**MAINE TURNPIKE AUTHORITY**

**ADDENDUM NO. 1**

**CONTRACT 2014.11**

**BRIDGE REPAIRS**

SP-53 (Revised 01/10/2014)

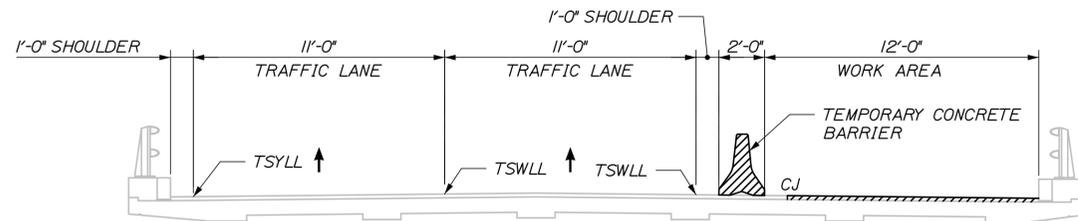
Pages SP-53 and SP -54 are deleted in their entirety and replaced with the attached pages SP-53 (Revised 01/10/2014) and SP-54 (Revised 01/10/2014).

Question 8: Specification 403 complimentary notes, note A and I are both noted, which is correct?

Question 17: Is the depth of the Stroudwater NB surface depth of 1 1/8" the correct depth of HMA? If the depth is correct is the type of HMA the correct stone size for the application? Also the plans state you are placing an 1 1/4" on sheet 16 of 32 and not the 1 1/8", which is correct?

Answer: The references to complimentary note I have been remove from the Table, see the attached pages SP-53 (Revised 01/10/2014) and SP-54 (Revised 01/10/2014).

Answer: RAP will be allowed in item 403.208, percentage per complimentary note B. RAP will not be allowed in 403.2081 per complimentary note J. See the attached pages SP-53 (Revised 01/10/2014) and SP-54 (Revised 01/10/2014).

Answer: The correct overlay depth is 1 1/4" for Stroudwater NB and MCRR NB, see revised Specifications 403 SP-53 and SP-54, included in this addendum.

BRIDGE REPAIRS - STROUDWATER RIVER & MAINE CENTRAL RAILROAD  
 NORTHBOUND TRAFFIC PHASING  
 SHEET NUMBER: 3  
 CONTRACT: 2014.11  
 3 OF 32

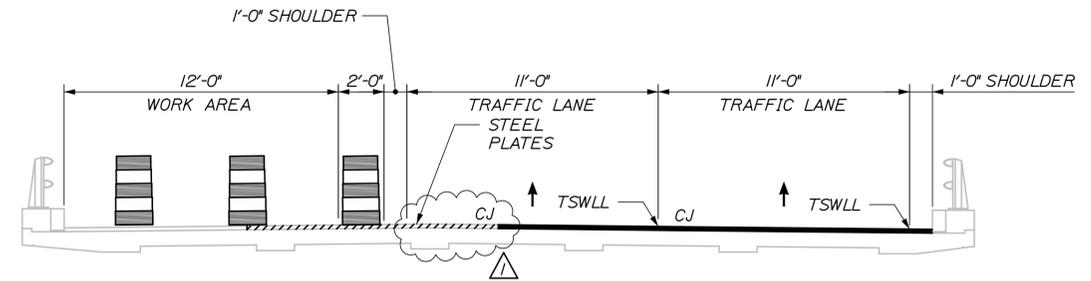
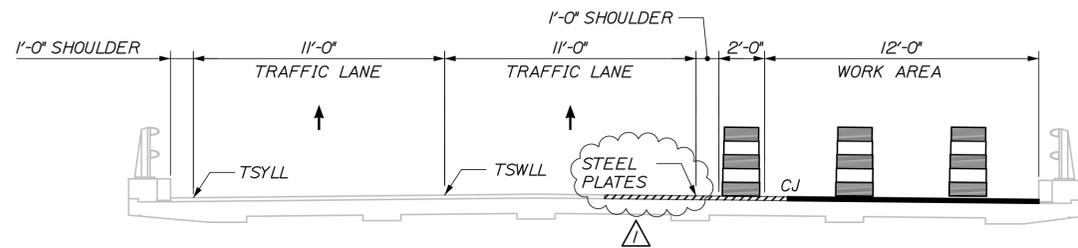
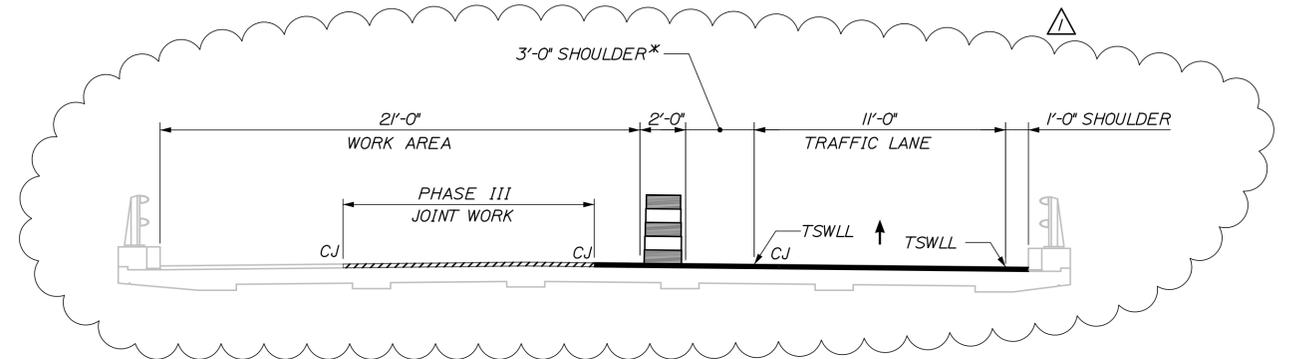
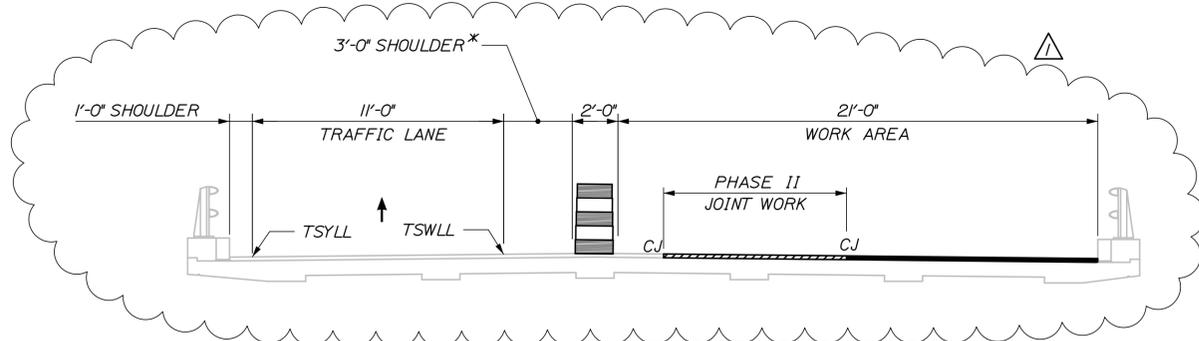
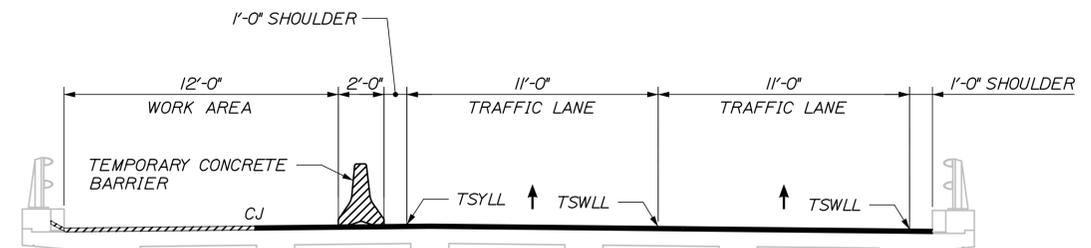
Sheets 3, 20 and 21 of 32 are deleted and replaced with the attached revised plan sheets.

The construction joint locations on phase 2 and phase 3 have been adjusted to permit wide loads to pass through the work zone during permitted lane closure hours.

\*▲ TRAVEL WAY SHALL BE A MINIMUM OF 15' WIDE DURING WIDE LOAD PERMITTED HOURS; ONE HALF HOUR BEFORE SUNRISE AND ONE HALF HOUR AFTER SUNSET.
